20/01788/FUL - 350 houses - Land at Shurdington Road Cheltenham

Review of further landscape material

Street Trees

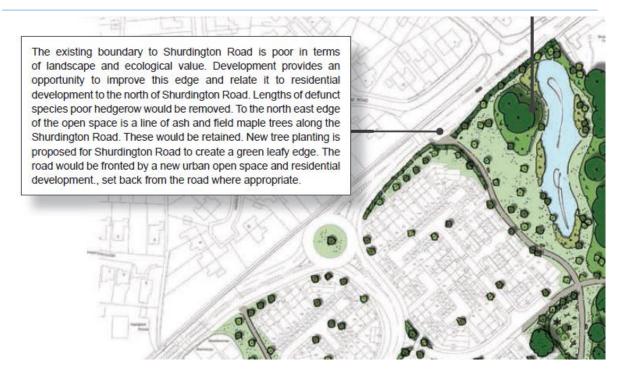
Since my initial comments in February 2021 the NPPF has been updated with a stronger requirement for tree planting in urban streets for a range of benefits in the current June 2021 version. The initial proposals showed some planting but not necessarily extensive. Brian Duckett has advised me that it is a matter the Applicant's Masterplanning team is aware of and a review of the current masterplan is underway.

The reason why the street trees are particularly important in this set of proposals is that the style of housing layout is such that there are limited front garden spaces in the dense arrangement of properties. Given the lack of open green space within the housing public realm e.g. verges or street ends the trees will likely be placed under water and root oxygen stress. The detailing of the trees' planting pits is critical to their chance of long-term survival and their sub-service detailing should be conditioned and developed to the satisfaction of Gloucestershire Highways Authority. Likewise their above ground growing space should be such that they do not cause nuisance to the owners of the new properties. The tree pit planting detail should be specifically conditioned to reflect its importance.

Likewise the actual trees themselves on planting should be the beneficiaries of Tree Preservation Orders. At planting they may not have the obvious amenity value to justify TPO's as applied to older trees but it is their potential that requires protection. It will also place a duty on the long-term managers of the development to replace any dead, diseased or dying stock so the vital street trees are not lost through wilful or accidental damage.
